ADDENDUM A
SOLICITATION #3450004900 / 20-FM-0042
01/31/2020

ODOT DIVISION V
BECKHAM COUNTY MAINTENANCE YARD
(SAYRE, OK)

This addendum contains corrections to the project specifications and plans.

Project: Oklahoma Department of Transportation – Beckham County Maintenance Facility
Location: Sayre, Oklahoma
Issued Date: 30 January 2020

SHEET
VA6.1

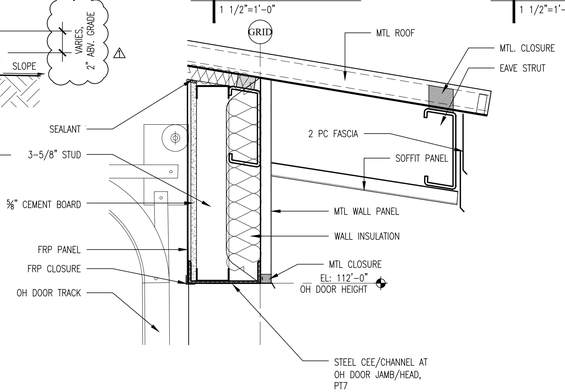
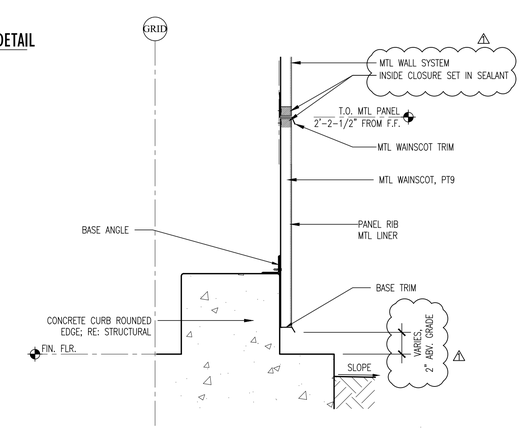
L. VA2.0 – Added PT9 to the Material Schedule and note 9 to the Material Schedule Notes.
M. VA6.1 – Added notes to details 8 and 9 indicating the inside closure set in sealant and that the bottom of the metal panel should remain 2" above grade.

SHEET
VS1.1

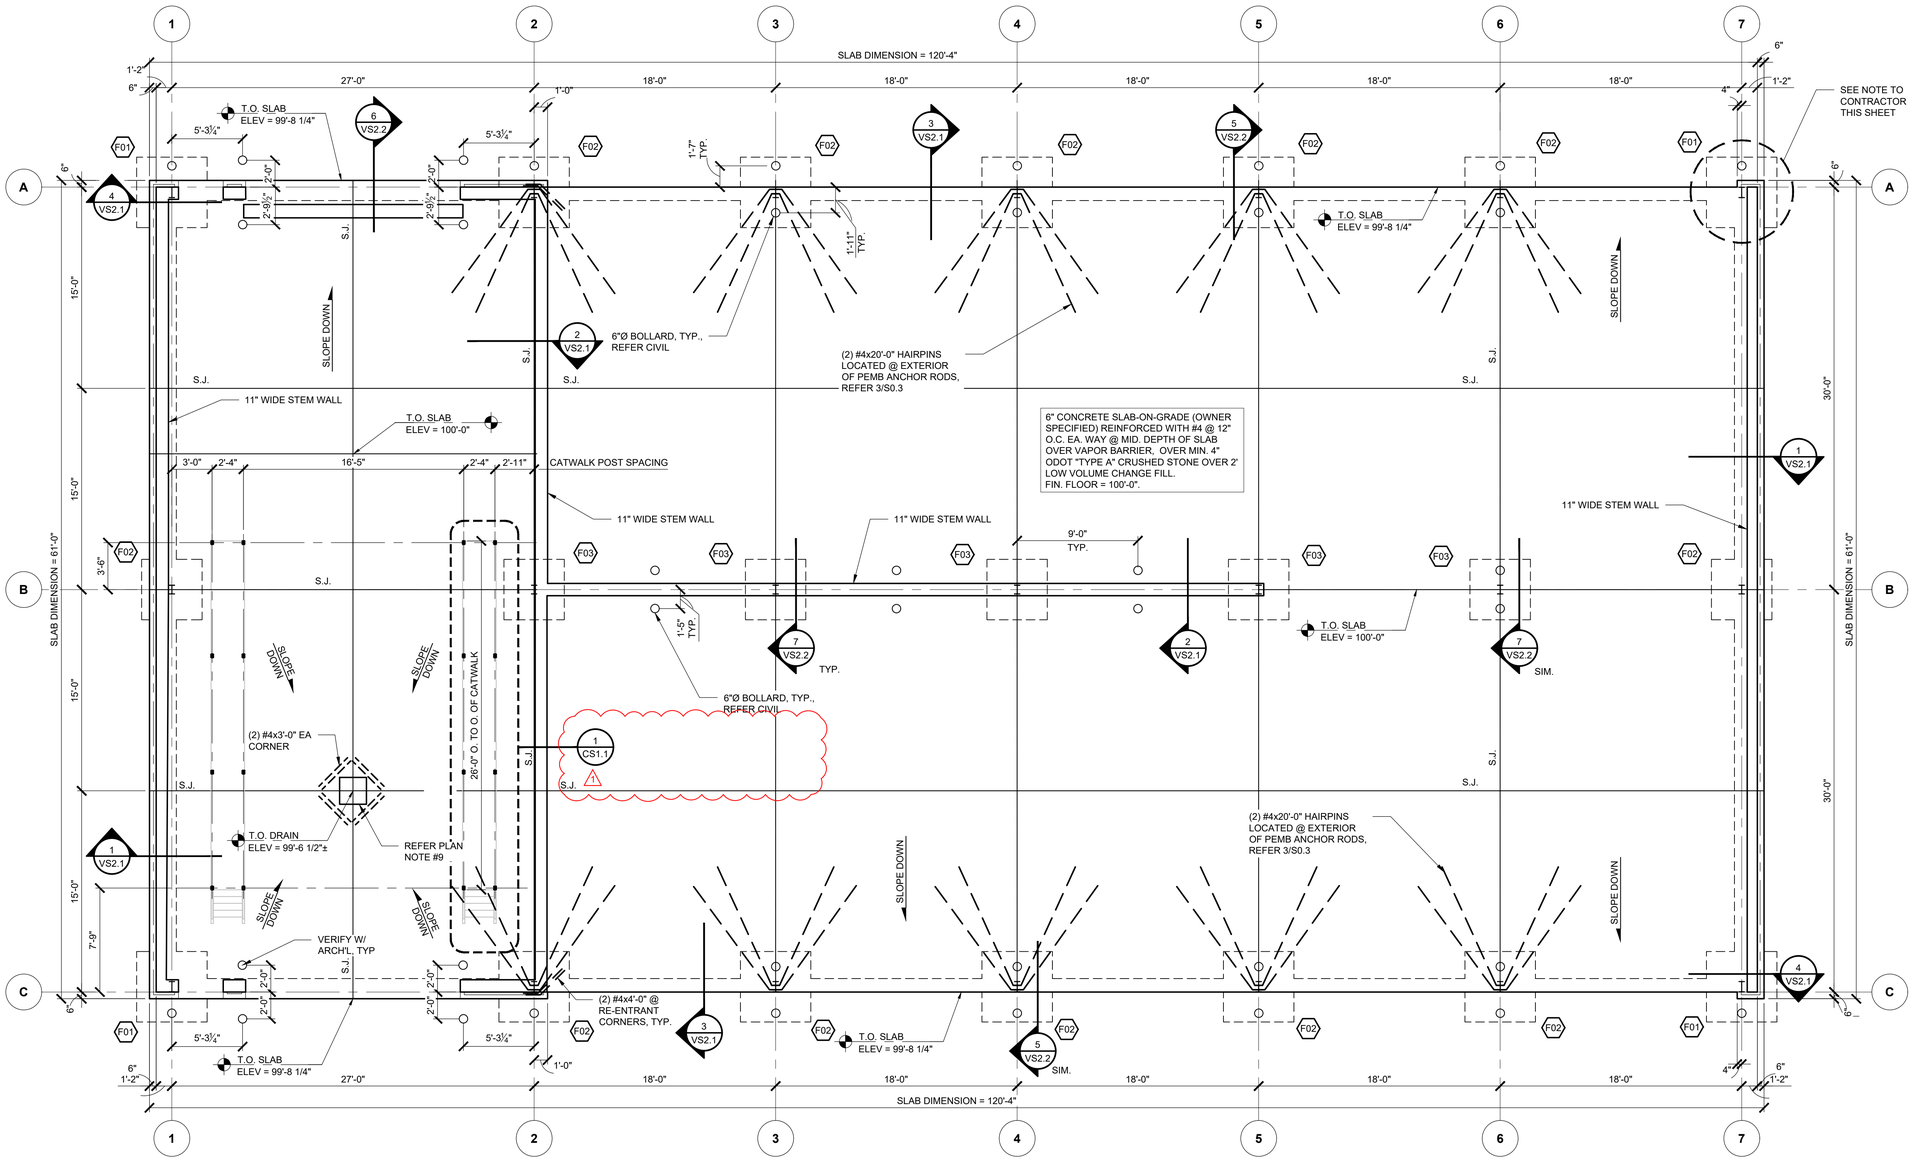
SHEET MP1.1	Replace sheet with attached; shifted floor sink near furnace & domestic water entry to avoid building foundations
SHEET VS1.1	Replace sheet with attached; refer to sheet CS1.1 for catwalk details

SHEET
VP1.1

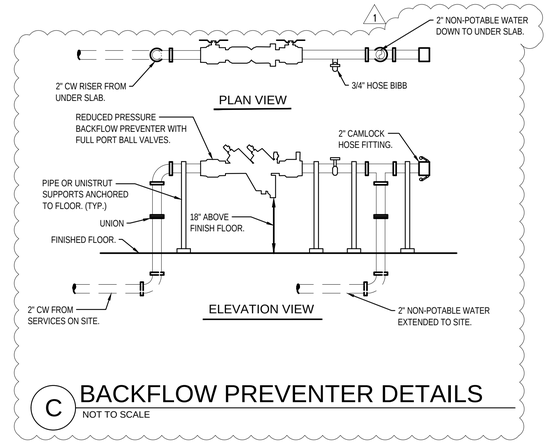
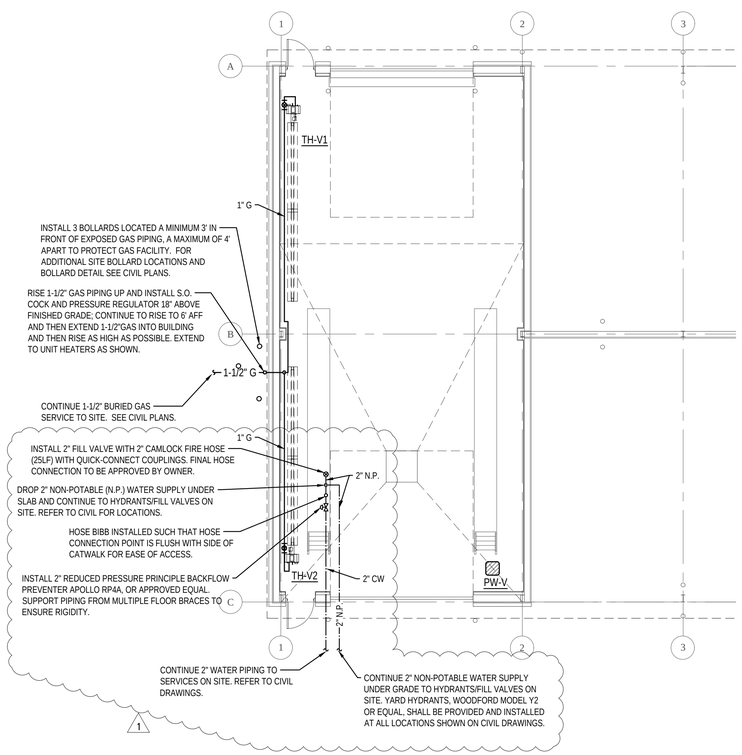
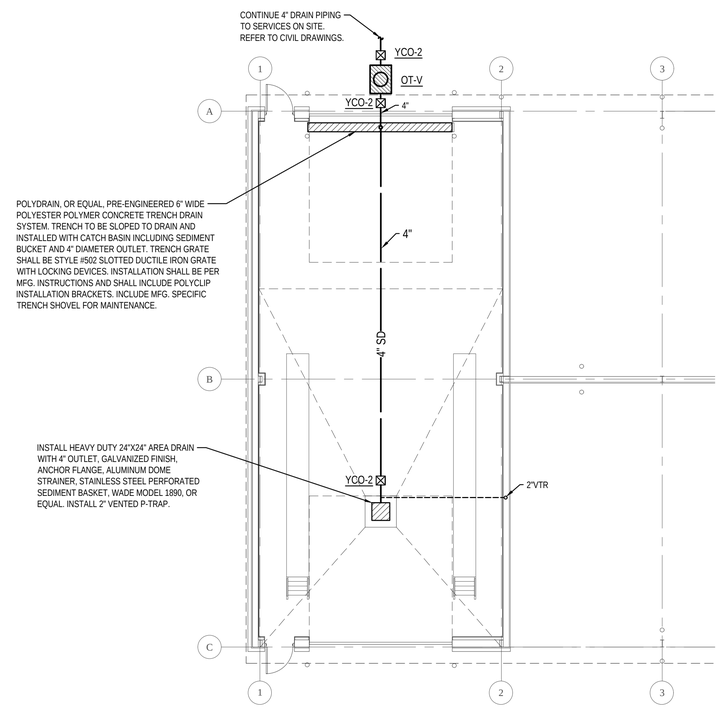
SHEET VP1.1	Replace sheet with attached; added backflow preventer detail & non-potable water piping, extended for Civil continuation on site
SHEET CS1.1	Replace sheet with attached; whole sheet revisions – catwalk is no longer pre-manufactured.
SHEETS HS1.1 & HS1.2	Replace sheets with attached; modified soil subgrade requirements at slab-on-grade; refer to sheet CS2.1 for catwalk details

SHEET
CS2.1

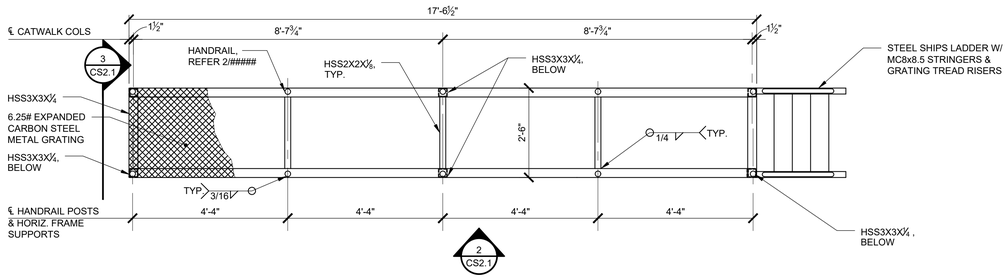
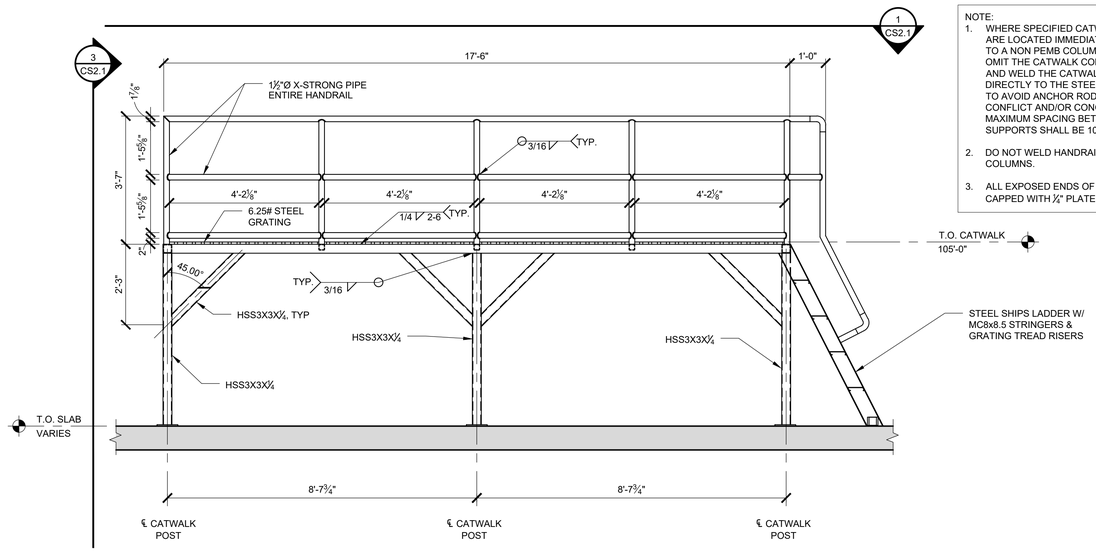
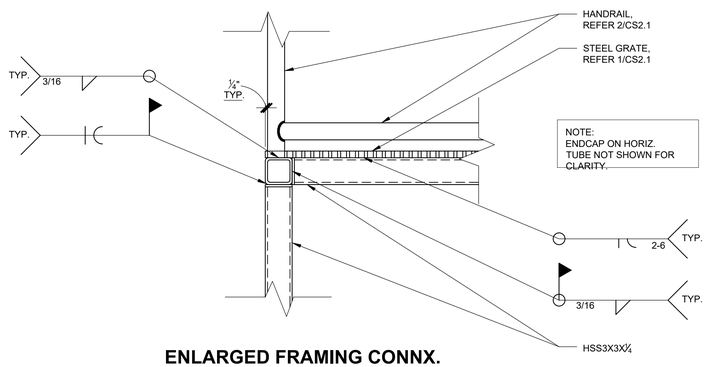
SHEET CS2.1	New sheet added to set – **"Catwalk Details"**
